SUBMISSION

YOUR REF: 2021/219

Submission: Objection to Development Proposal

10 Pacific Dr. Application number 2021/219 Laurus Projects Pty Ltd

Figure 1 Height non-compliance

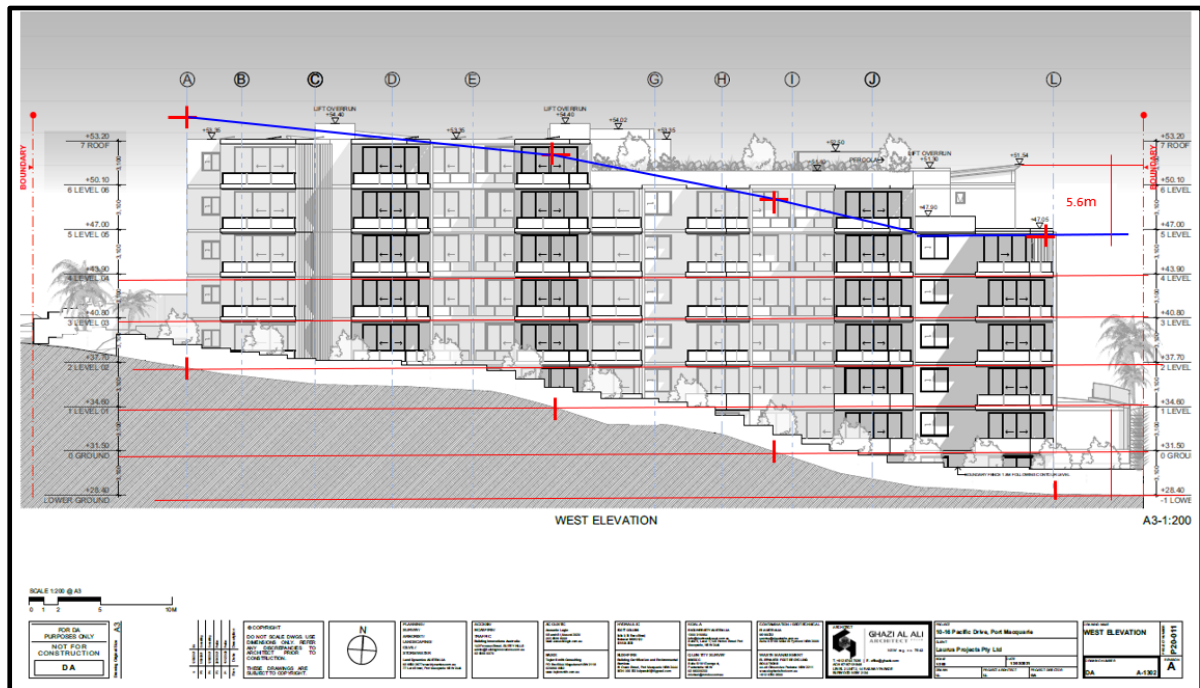
We note that the land zoning for the area is R3, which has a maximum height limit of 17.5m. Much of the proposed development appears to be 2-3 m above the height, with the rear 5.6m beyond the upper limit. Figure 1 shows the height non-compliance

The SEE document states that the architects have tried to strictly adhere to the 17.5 limit when what the architects were supposed to work hard to do was work within the limits.

Figure 3 Rear neighbour homes - gutter heights sourced from DA Plan A-1102

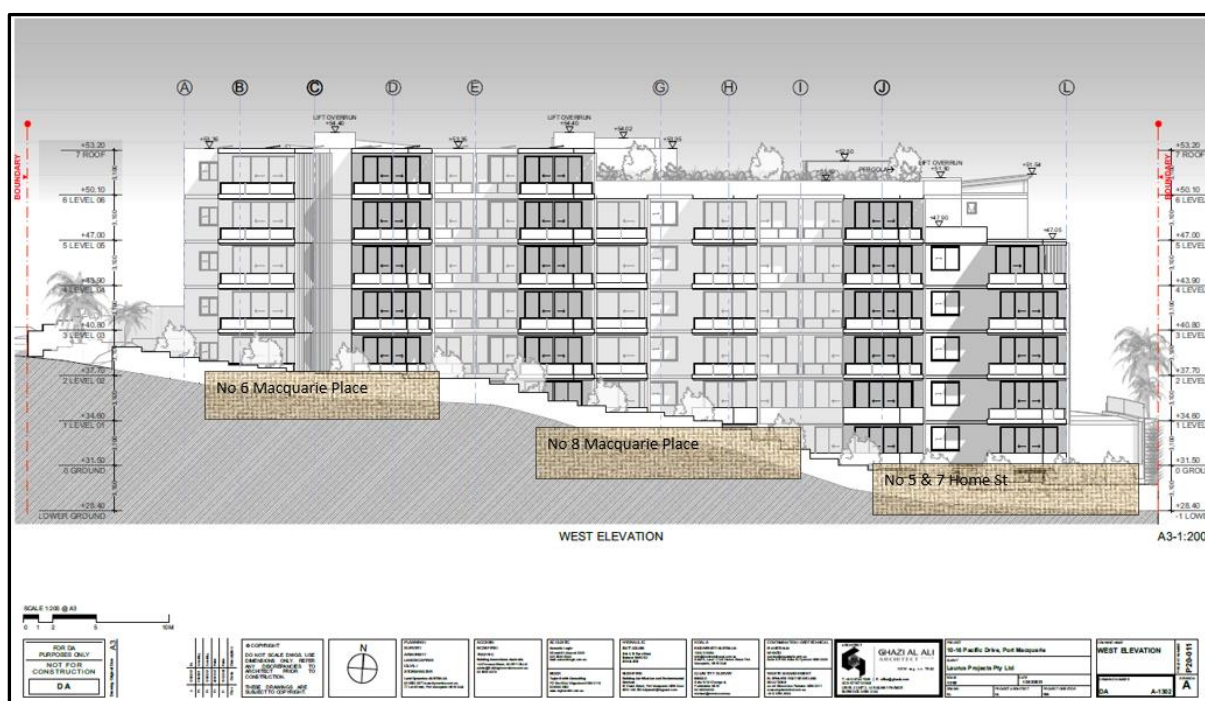
The development has a very vertical rear façade, with 66 balconies looking directly into your backyards. From the rear neighbours perspective, it will look overbearing and will cause significant overshadowing, noise, privacy and light pollution issues. Figure 2 from the SEE shows an artist's view of the development and its surrounding neighbours. Note: high perimeter retaining walls have been omitted. Figure 3 shows the West Elevation of the development with the surrounding neighbours.

The SEE Executive Summary states that “The height variations do not result in an unacceptable or overbearing visual appearance from Pacific Drive” but does not mention “unacceptable or overbearing visual appearance to Home St and Macquarie Place neighbours”. Instead, the SEE states “no impacts arise on adjoining properties as result of the height non-compliance. **We strongly refute this statement.** The overshadowing diagrams show significant increased shadowing on our homes and Figure 3 above clearly shows that the proposed development has severe visual, privacy, noise and light pollution issues.

Figure 7 - undocumented stormwater collection pipes and pits at 2 Macquarie Place from several Windmill St properties

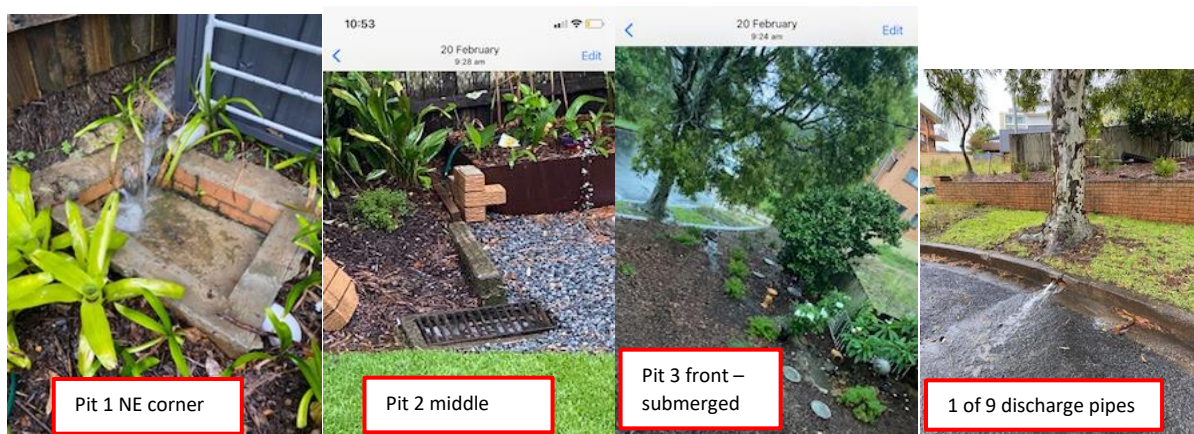
- A. The garages of the block of units at 2 Oxley Crescent have significant groundwater inundation during most storms. Groundwater seepage continues for weeks afterwards.
- B. The vacant block at 2A Oxley Crescent has significant overland stormwater issues during most storms, see Figure 3 below. Groundwater from the site would be adding to flooding of A. above.
- C. No. 2 Macquarie Place receives undocumented piped stormwater from several Windmill St properties and overland stormwater from No.10 & 12 Windmill St. See Figures 6 & 7.

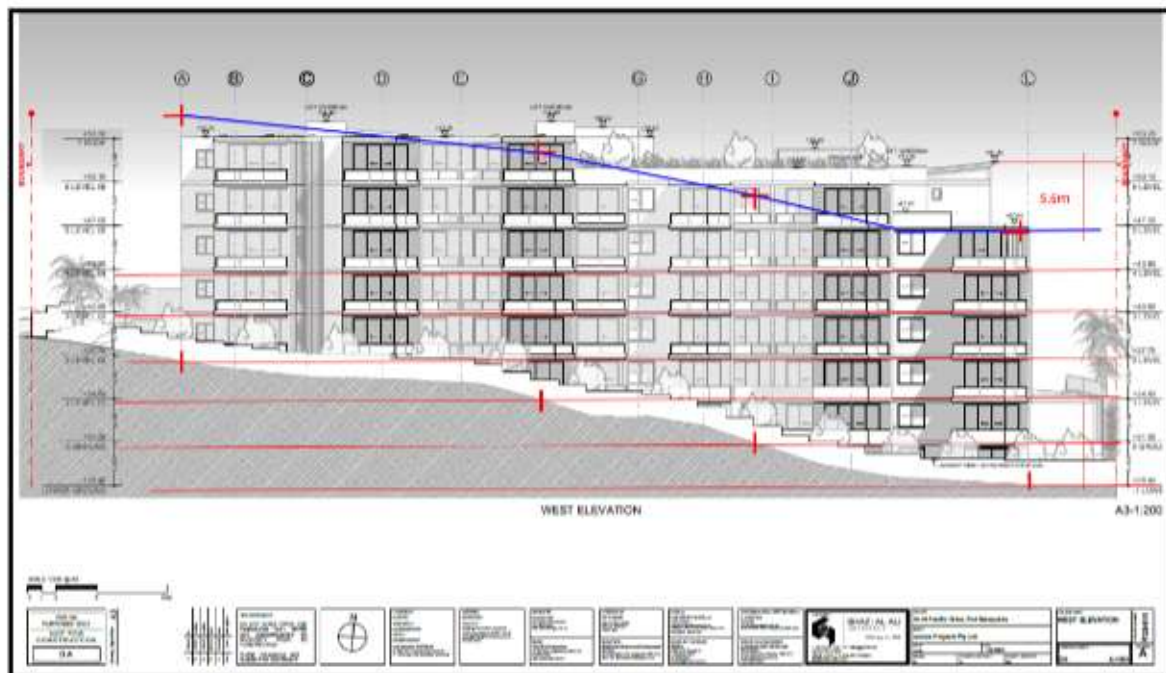
upper limit. Figure below shows the height non-compliance

Figure 3 Rear neighbour homes - gutter heights sourced from DA Plan A-1102

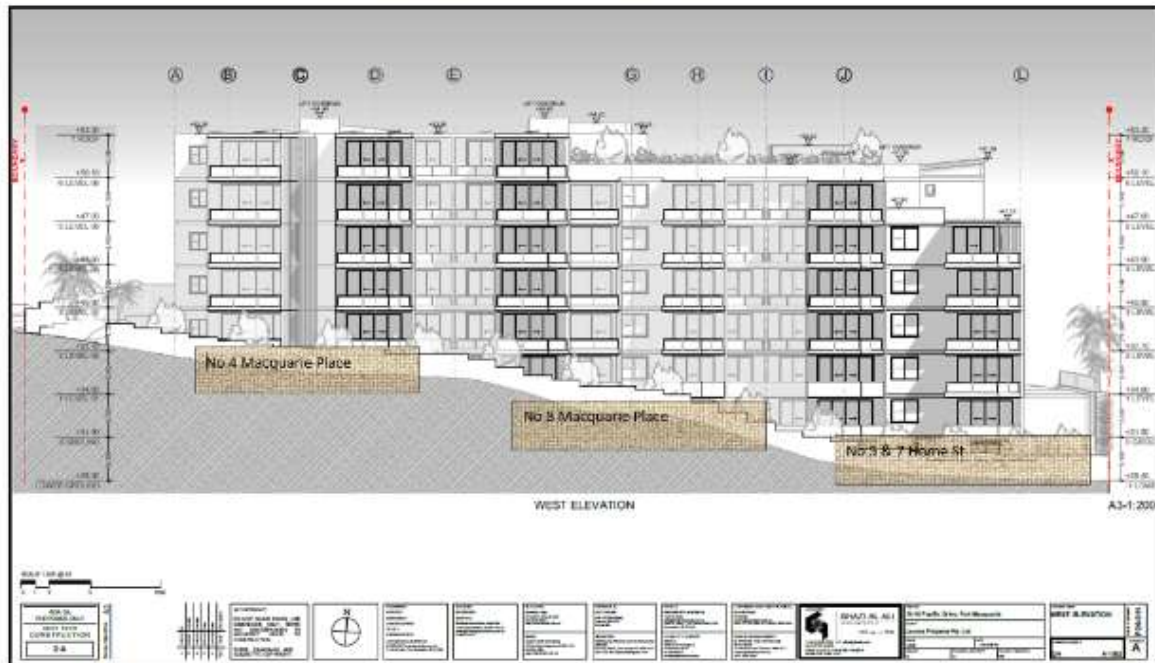
Architects havenot worked within the height limits. The applicant has requested a variation to the height which seems unreasonable and this I strongly object to. The property is sloping and I realise this but my adjacent low density residential property will be overshadowed and block easterly morning sun. This is totally unacceptable and the issues that will arise are substanbtial. Loss of privacy for the dwellings on Macquarie Place are significant wioth 66

balconies overlooking the backyards of the houses creating noise issues, privacy issues and significant light pollution.

The SEE Executive summary states that “The height variations do not result in an unacceptable or overbearing visual appearance from Pacific Drive” but does not mention “unacceptable or overbearing visual appearance to Home St and Macquarie Place neighbours”. Instead, the SEE states “no impacts arise on adjoining properties as result of the height non-compliance. We strongly refute this statement. There has been no care or consideration of neighbours to the rear and side whatsoever.

Fig 4: Trees rear Nos 2 & 6 Windmill Street

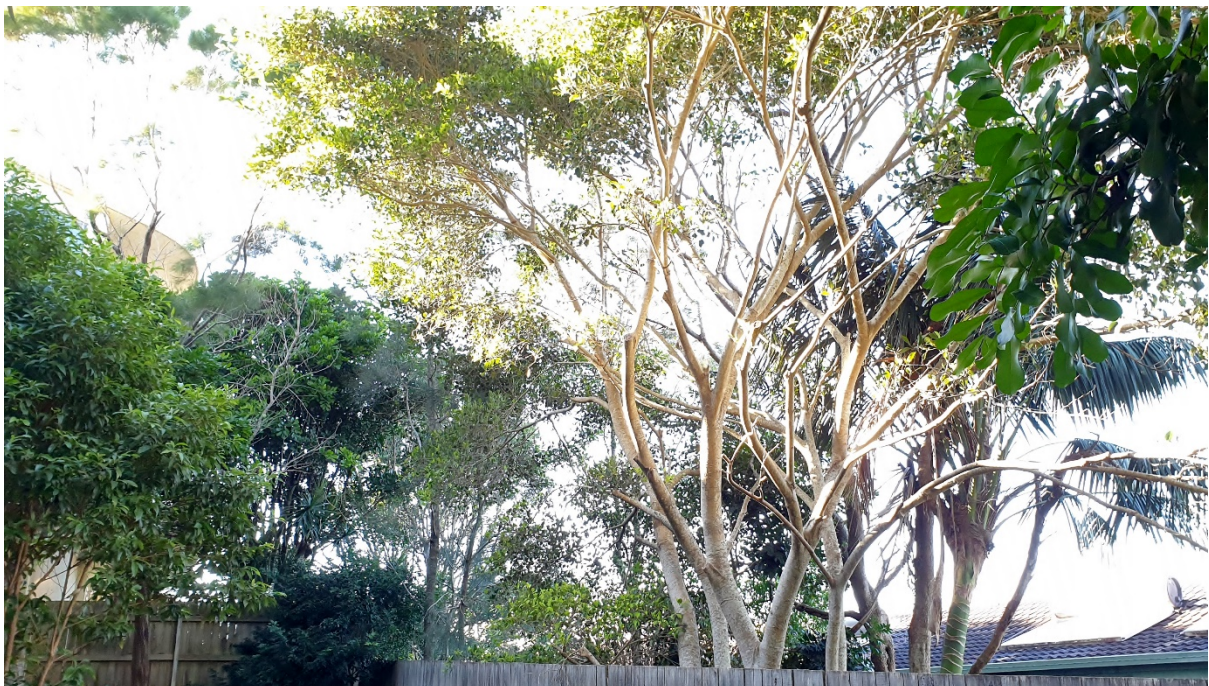
The proposal involves the removal of several mature trees along the northern border at the rear of Nos 2 & 6 Windmill Street. These trees are part of the koala corridor, attract birdlife to the area and form a privacy screen for residents.

The Statement of Environment Effects, Pg 11 states "Removal of all vegetation, with no significant vegetation identified on the site currently." The figure above clearly shows that there is significant vegetation on the site.

We are strongly opposed to the removal of these trees as they provide habitat for koalas and birds plus provide a privacy screen for residents.

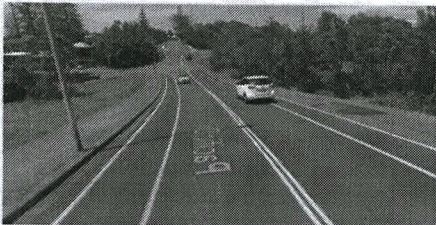
The photos claiming to show “appropriate distance” and “appropriate additional width” are deceptive. They were taken from a device mounted about one and a half metres above the roof of a vehicle, which is not an indication of the visibility from an ordinary car trying to turn right onto Pacific Drive from Windmill Street. (The white vehicle was seen by witnesses.) Their images artificially flatten the crest and widen the angle, making the road and bicycle path look wider and oncoming cars more visible than is actually the case. The photographs provided by Land Dynamics Australia have been cropped or photo-shopped so that the KOALA and PEDESTRIAN ACTIVITY warning signs are not visible. Our photograph (attached) shows the KOALA sign (indicating the presence of koalas in the area) and down the hill the top only of the PEDESTRIAN ACTIVITY sign (because of the steep incline.)

*PHOTO TAKEN FROM
ELEVATED HEIGHT—
COMPARE WITH OUR
PHOTO TAKEN FROM THE
DAVER'S SEAT !!*

Appropriate distance can be seen to the vehicle at the top of the crest adjacent to the intersection of Windmill St and Pacific Drive.

Appropriate additional width for overtaking a vehicle turning appears to be provided via the additional bicycle path and hard standing bitumen roadway extension as seen below should it be required.
